1. PURPOSE AND SCOPE OF THIS MEMORANDUM

This memorandum summarizes a site survey performed on July 18, 2008 to evaluate the condition of ADA-mandated accessibility at the Council on Aging in Pembroke Massachusetts. After a description of the site and interior conditions of the building, recommended improvements are provided in Section 7, beginning on page 8.

The subject property is the Pembroke Council on Aging at 148 Center Street.

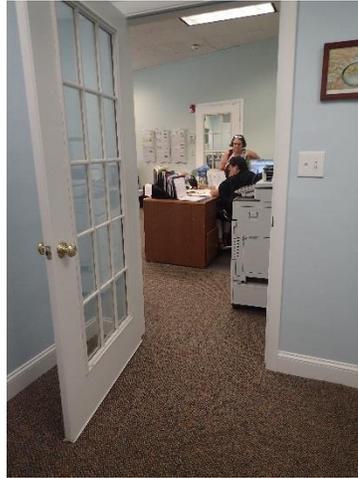
Both exterior doors have power operators. The interior vestibule at the West entrance is non ADA-compliant due to the limited distance between the inner and outer doors; 4'-8" is provided instead of the required 7'-0" (7'-6" may actually be required in this case due to the large (42" wide) interior door. However, this may not be a violation if the inner door is fixed in its open position whenever the facility is in operation.

There is also only 12" of space at the latch-pull side of the interior door, where 18" is required.

- a. West Entrance Vestibule  
Reconfigure the vestibule and/or inner door to provide the required door clearance dimensions in the vestibule. This will require additional design analysis, but may involve reducing width or changing the swing of the inner door. Building Code considerations may also apply, based on the occupancy classification and number of occupants in the building.

- d. Door Clearances and Swings  
Reconfigure or relocate door openings and/or change door swings to allow 18" clear at the latch-pull side of doors, plus 12" clear at the latch push side where the door is equipped with a closer. This will primarily affect the West entrance vestibule, as discussed above.

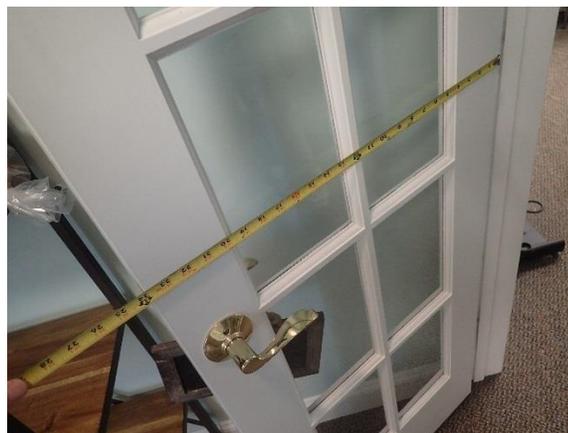
- Lack of appropriate hardware. Most doors have standard doorknobs, which cannot be operated with a closed fist or without grasping. Lever handles or simple push-pull hardware are required.

- b. Interior Signage  
Provide consistent ADA-standard signage for all accessible doorways, routes and spaces.
- c. Door Hardware – priority items  
Provide lever-handle hardware at any doors expected to be used by the general public. Ensure single-action release (from the room or exit side) of doors subject to locking (i.e., no separate deadbolts, etc.)
- d. Service Counters – interim accommodation  
Where ADA-accessible height (36" or less) counters are not available, ensure that alternate accommodation is available. This can include a desk or table of appropriate height in the same service area, equally accessible to all users.
- e. Door Clearances – furniture interference  
Remove or relocate furniture to allow 18" clear at the latch-pull side of doors, plus 12" clear at the latch *push* side where the door is equipped with a closer.
